LOT / PHASE	REG. PLAN #	HOUSE TYPE	TEL:
29 / 1	65M-4671	GLENWAY 3A ELEV 2

GLENWAY 3A • 2,866 SQ.FT.

LOWER LE

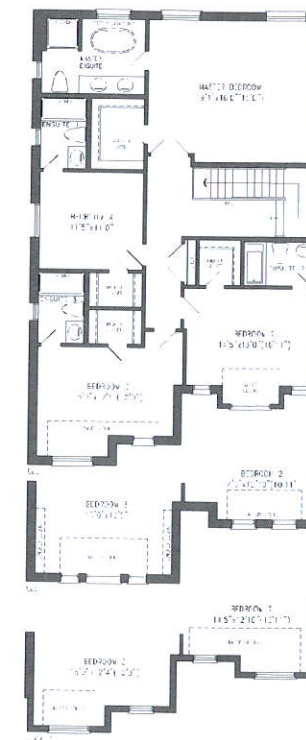
1 - ENLARGE BASEMENT WINDOWS (MAY REQUIRE WINDOW WELLS) - WINDOW IS 30 INCHES X 24 INCHES	RECEIVED
13Oct20 Note:	NEW
2 - ENLARGE 2 BASEMENT WINDOWS(MAY REQUIRE WINDOW WELLS)-WINDOWS ARE 30X24 INCHES-SEE SKETCH	RECEIVED
18Sep20 Note:	NEW
